**Issues relating to the Globally Harmonized System
of Classification and Labelling of Chemicals:
Use of the Manual of Tests and Criteria in the
context of the GHS**

Comments on INF.3/Add.1, figures 10.1 and 10.4

**Transmitted by Australian Explosives Industry and Safety Group
Incorporated (AEISG)**

Figure 10.1: OVERALL SCHEME OF THE PROCEDURE FOR CLASSIFYING A SUBSTANCE OR ARTICLE IN THE CLASS OF EXPLOSIVES

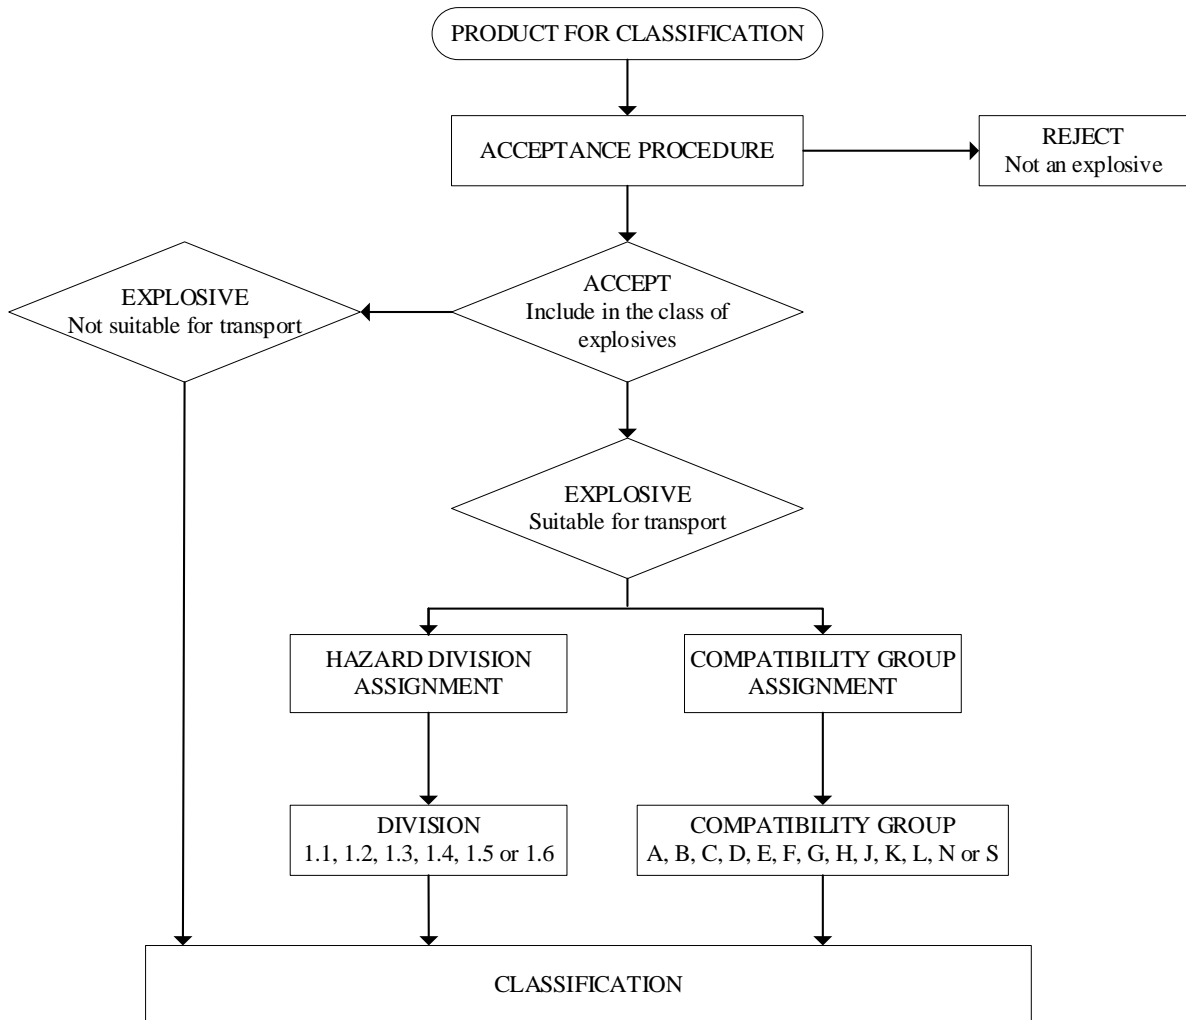
Alternative figure 10.1

The term “unstable” as applied to explosives in the context of GHS generates confusion and can be avoided in Table 10.1 as shown below.

Figure 10.4: PROCEDURE FOR AMMONIUM NITRATE EMULSION, SUSPENSION OR GEL, INTERMEDIATE FOR BLASTING EXPLOSIVES

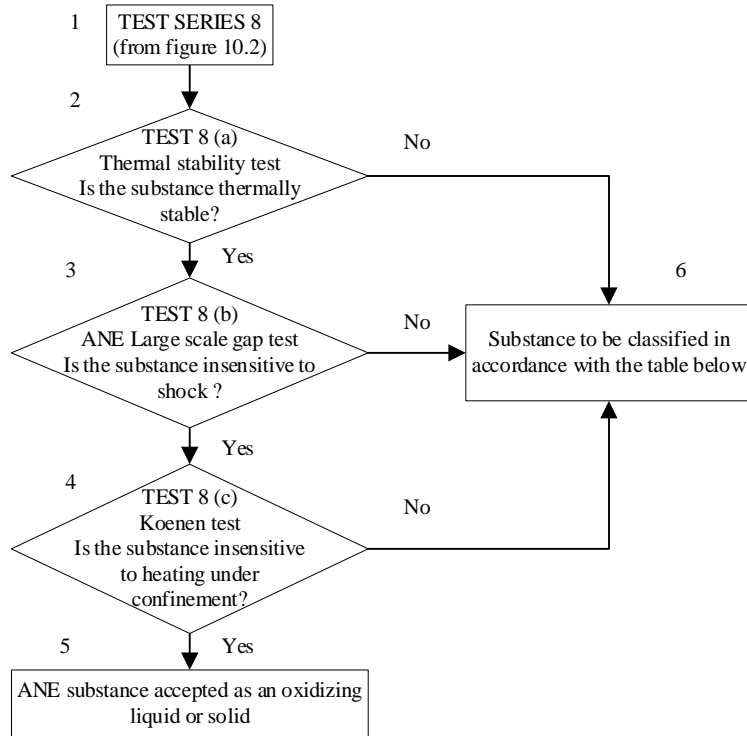
Alternative figure 10.4

AEISG believes that Figure 10.4 needs a rethink given it is now relevant to GHS.

It is the opinion of AEISG that boxes 7 and 8 should never have been different.

An ANE which fails either of these tests, 8(b) or (c), is a candidate for Division 1.5:

- If it passes TS5, it is Division 1.5.
- If it fails TS5, it is Division 1.1.

The issue which complicates things is an ANE product which fails Test 8(a) – refer Box 2. It is then EITHER an unstable Explosive OR an unstable Oxidising substance, depending on the results of TS8(b) and (c).

The diagram for Figure 10.4 then becomes overly complex.

AEISG proposes an alternative Figure 10.4 with a “Results table” included which we believe is far simpler to interpret.

Test 8 (a)	Test 8 (b)	Test (c)	CLASSIFICATION
Pass (-)	Pass (-)	Fail (+)	Classify as an explosive
Pass (-)	Fail (+)	Pass (-)	Proceed to Test Series 5 to determine hazard division
Pass (-)	Fail (+)	Fail (+)	Classify as an unstable explosive (not suitable for transport)
Fail (+)	Pass (-)	Fail (+)	
Fail (+)	Fail (+)	Pass (-)	
Fail (+)	Fail (+)	Fail (+)	Classify as an oxidizing solid or liquid, not suitable for transport
Fail (+)	Pass (-)	Pass (-)
